HN-215.2\*  
 DN-156.2\*  
 EN-46.2\*  
 FN-34.2\*  
 NN-010

# SERVICE BULLETIN

## OVERRUNNING CLUTCH OUTER RACE INSPECTION

Figure 1. Inspection of Overrunning Clutch Assembly Outer Race.

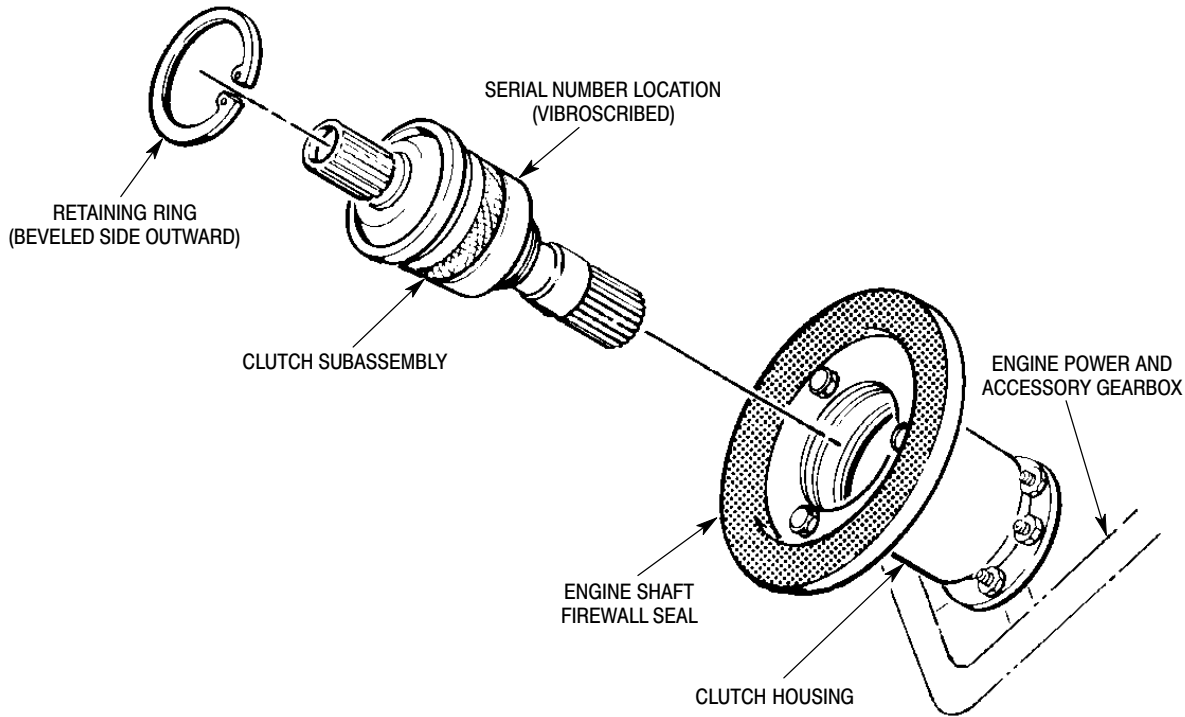
A. Inspect aircraft records to determine what serial number outer race (369A5352-BSC) is installed in the overrunning clutch assembly.

C. Inspect outer race and record serial number of outer race in Log Book.

Serial numbers are clearly vibroscribed on outer surface of the outer race on affected parts. (See Figure 1.)

D. If the outer race serial number is not 0692 thru 0927, proceed to step F. If the outer race serial number is 0692 thru 0927, proceed to step E.
